***Planning Department
Transportation Development Services***

**Re: ABQ Uptown Assisted Living
7611 Indian School Rd., NE
Traffic Circulation Layout**
Engineer's/Architect's Stamp dated 10-28-15 (H19-D082)

Based upon the information provided in your submittal received 10-29-15, the above referenced plan cannot be approved for Building Permit until the following comments are addressed:

DATE 10-28-2015
SHEET NUMBER C-1.0

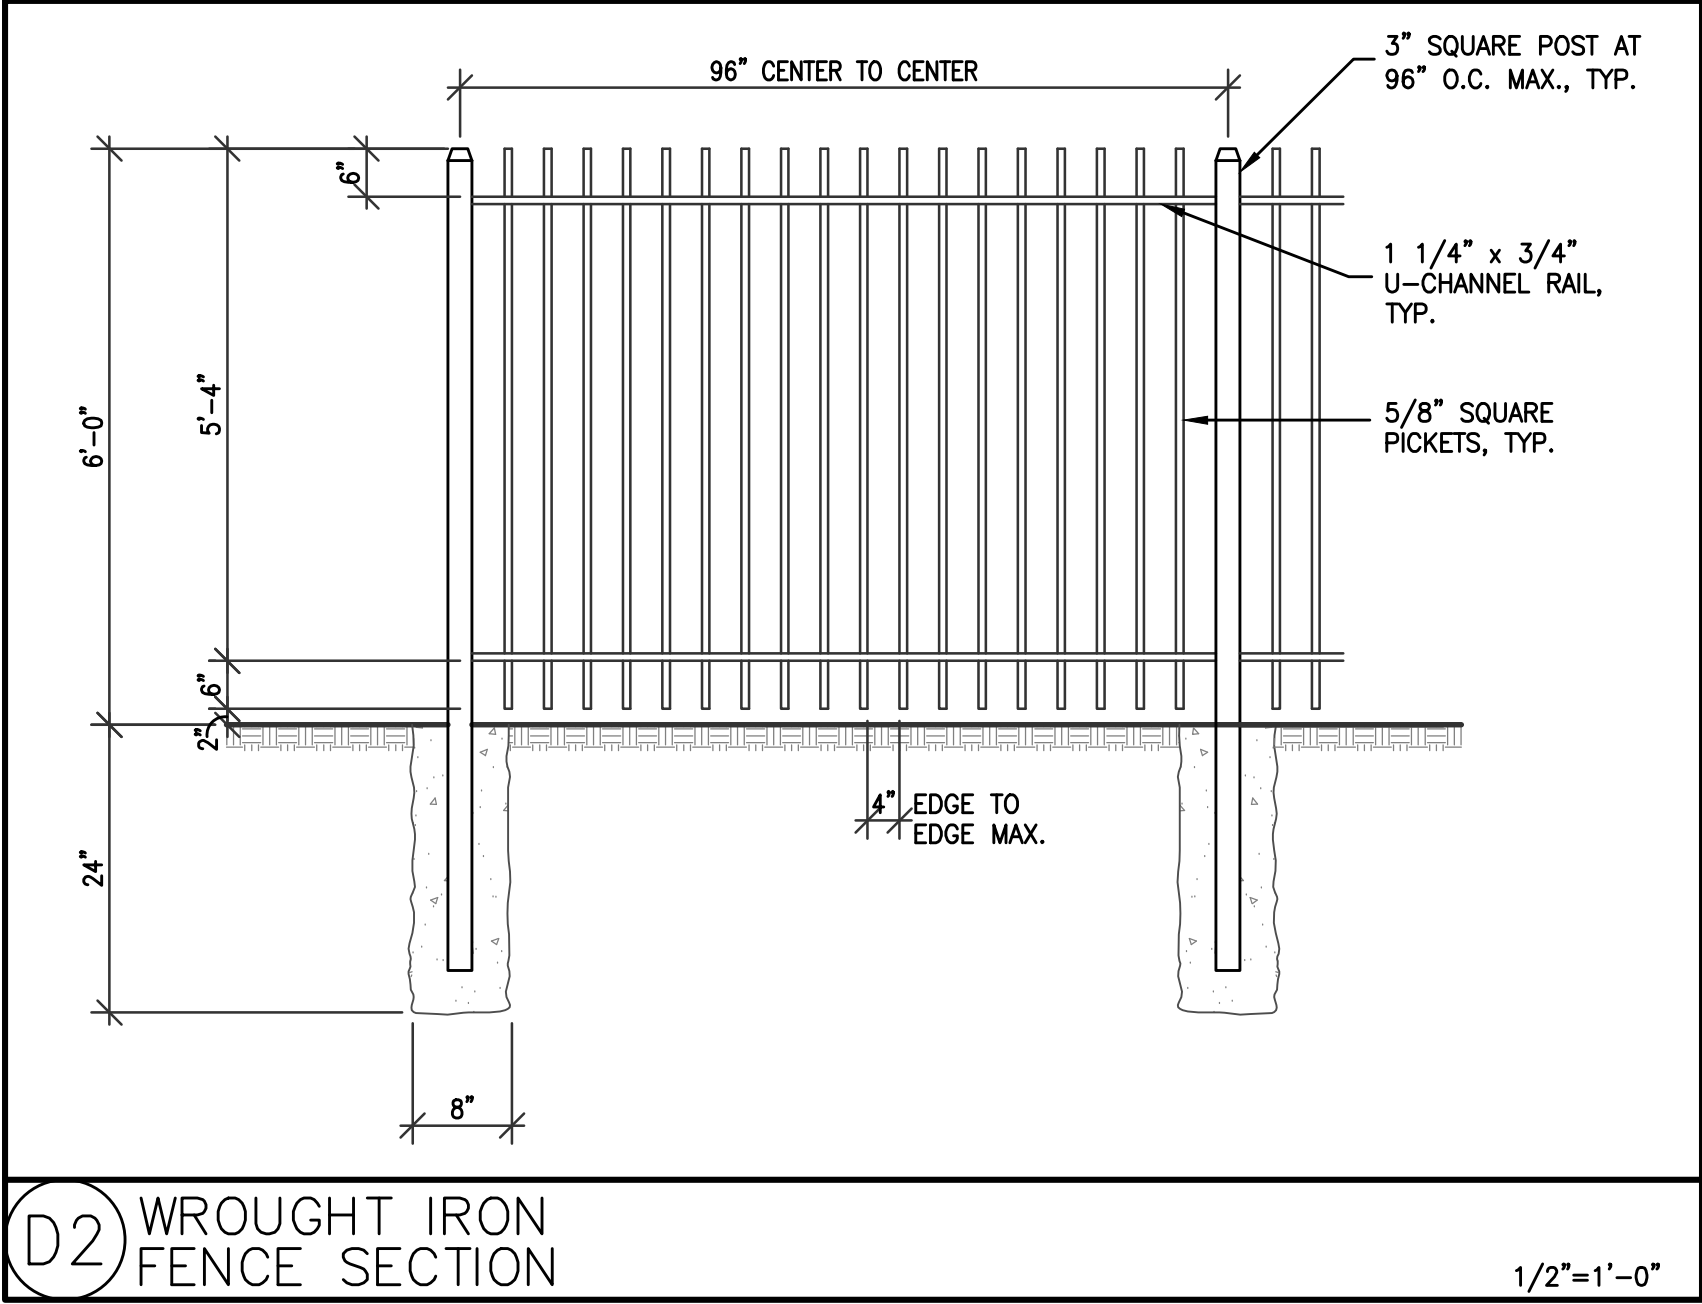
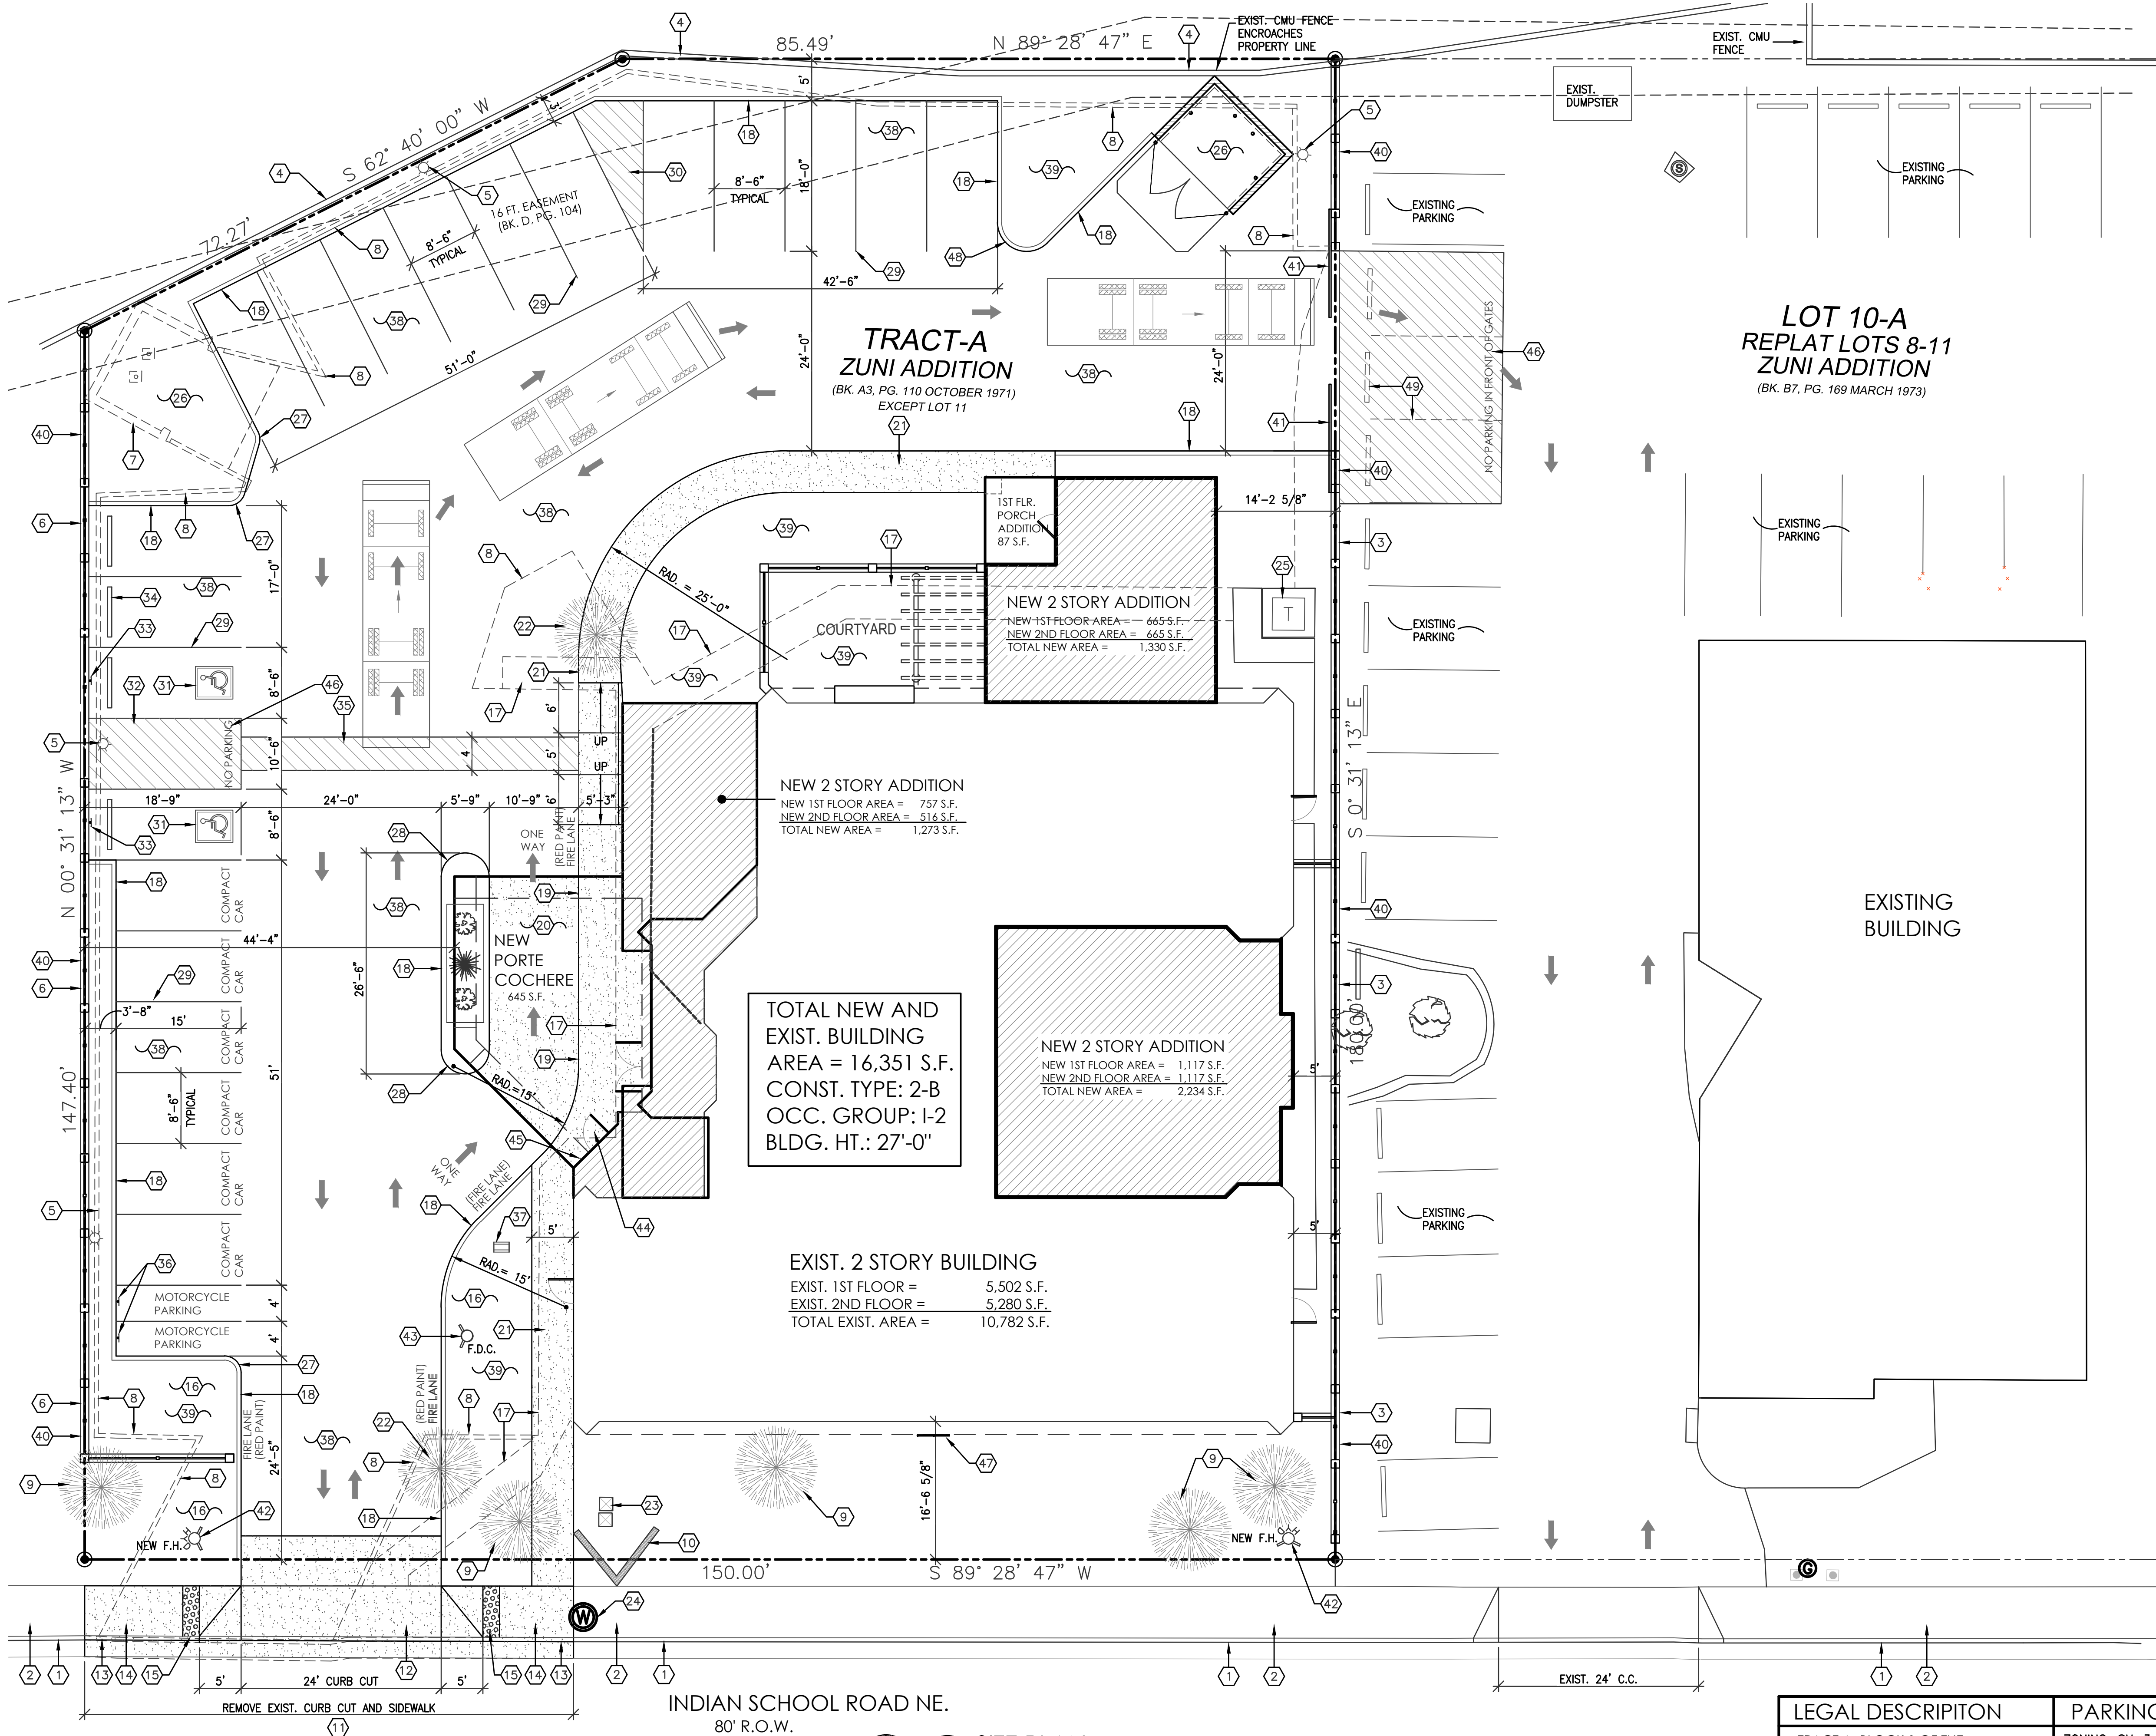
1. Per the DPM, a 6 ft. wide ADA accessible pedestrian pathway is required from the public sidewalk to the building entrances. Please clearly show this pathway and provide details. In review of drawing C-1.0, the proposed pedestrian pathway is only 5 ft. wide.
2. Per the DPM, a 6 ft. wide ADA accessible pedestrian pathway is required from the HC parking stall access aisles to the building entrances. In review of drawing C-1.0, the proposed pedestrian pathway is only 4 ft. wide.
3. Service vehicle and/or refuse vehicle maneuvering must be contained on-site; provide a copy of refuse approval.
4. Please provide a sight distance exhibit (see the *Development Process Manual, Chapter 23, Section 3, Part D.5 Intersection Sight Distance*). Please provide this detail for both entrance/exits on Indian School Rd.(Tract A and Lot 10-A)
